Subdivision Authority

File NO. LDA15-0091

RE: Tentative plan of subdivision to create 95 single detached residential lots and 44 semi-detached residential lots, from the NW 13-51-25-W4M located south of 28 Avenue SW and east of 141 Street SW; **CHAPPELLE**

SUBDIVISION CONDITIONS OF APPROVAL MAP

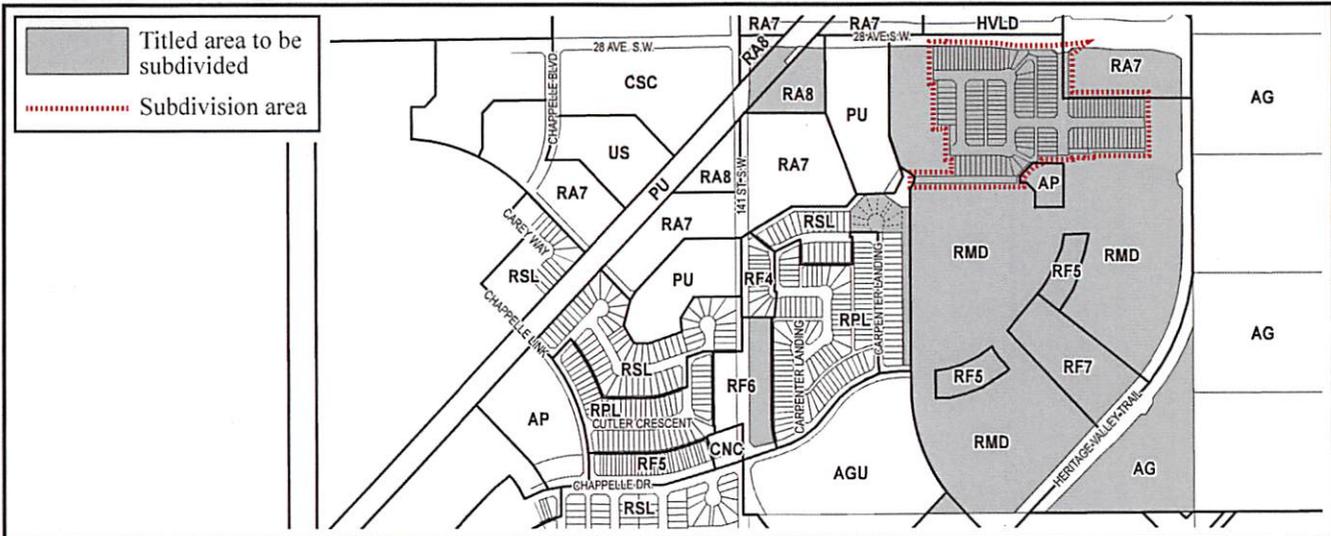
3. that the owner dedicate the greenway as road right of way as shown on the "Conditions of Approval" map, Enclosure I;
4. that the subdivision boundary be amended to include the dedication of additional road rights of way for 28 Avenue SW and Heritage Valley Trail SW to conform to an approved Concept Plan, or to the satisfaction of Transportation Services, as shown on the "Conditions of Approval" map, Enclosure II;

7. that the engineering drawings include a temporary 4 m gravel surface emergency access with T-bollards, to the satisfaction of Transportation Services, as shown on the "Conditions of Approval" map, Enclosure I. This roadway will be required prior to CCC for roads (or when required by Transportation Services);

8. that the engineering drawings include two temporary 12 m radius gravel surface turnarounds with bollards or mini-barriers to the satisfaction of Transportation Services, as shown on the "Conditions of Approval" map, Enclosure I. These turnarounds will be required prior to CCC for roads (or when required by Transportation Services);

9. that the engineering drawings include two temporary 6 m gravel surface roadway connections to the satisfaction of Transportation Services, as shown on the "Conditions of Approval" map, Enclosure I. These roadways will be required prior to CCC for roads (or when required by Transportation Services);

10. that the engineering drawings include 200 mm and 300 mm offsite water main connections, to the satisfaction of EPCOR Water Services Inc., as shown on the "Conditions of Approval" map, Enclosure I;

13. that the owner construct a 3 m hard surface shared use path with a dividing yellow centerline, "Shared Use" signage, lighting, and bollards, to the satisfaction of Transportation Services, as shown on the "Conditions of Approval" map, Enclosure I;

14. that the owner construct a 1.5 m concrete sidewalk with lighting and bollards, to the satisfaction of Transportation Services, as shown on the "Conditions of Approval" map, Enclosure I;

15. that the owner pay for the installation of traffic signals, as shown on the "Conditions of Approval" map, Enclosure I. The City of Edmonton shall complete the signal design, and the City's Electrical Services Contractor must install the signals as per the agreement between the City of Edmonton and the Electrical Services Contractor. The timing of the traffic signals installation will be at the direction of Transportation Services. If traffic signals are not deemed warranted by Transportation Services within 5 years of signing the Servicing Agreement, the owner will be required to provide payment to the City of Edmonton for the installation of traffic signals at that time to fulfill this obligation;

16. that the owner construct a 1.8 m noise attenuation fence contained wholly within private property, as per the City of Edmonton Roadway Design Standards Drawing #5205, for all lots backing onto or flanking 28 Avenue SW, to the satisfaction of Transportation Services, as shown on the "Conditions of Approval" map, Enclosure I;

17. that the owner construct all fences wholly on privately-owned lands, to the satisfaction of Transportation Services and Sustainable Development, as shown on the "Conditions of Approval" map, Enclosure I; and

SUBDIVISION CONDITIONS OF APPROVAL MAP

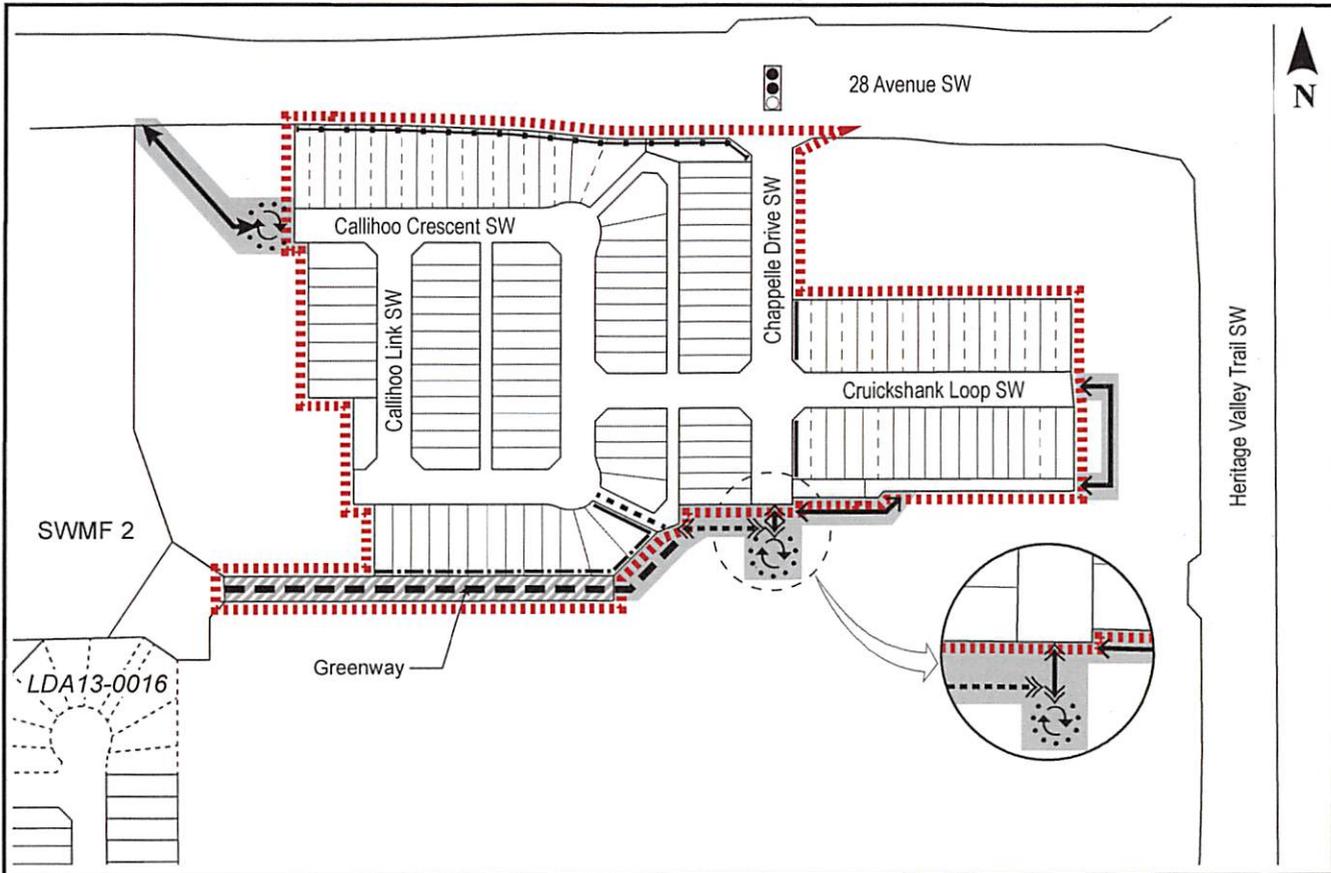
5. that subject to Condition I (4) above, the owner clear and level 28 Avenue SW and Heritage Valley Trail SW as required for road right of way dedication;

11. that the engineering drawings include the first two (2) lanes of 28 Avenue SW to an arterial roadway standard including channelization, accesses, intersections, shared use path, sidewalk, lighting, landscaping and any transitional improvements, to the satisfaction of Transportation Services, as shown on the "Conditions of Approval" map, Enclosure II. Preliminary plans are required to be approved for 28 Avenue SW prior to the approval of engineering drawings for the arterial roadway and subdivision, to the satisfaction of Transportation Services;
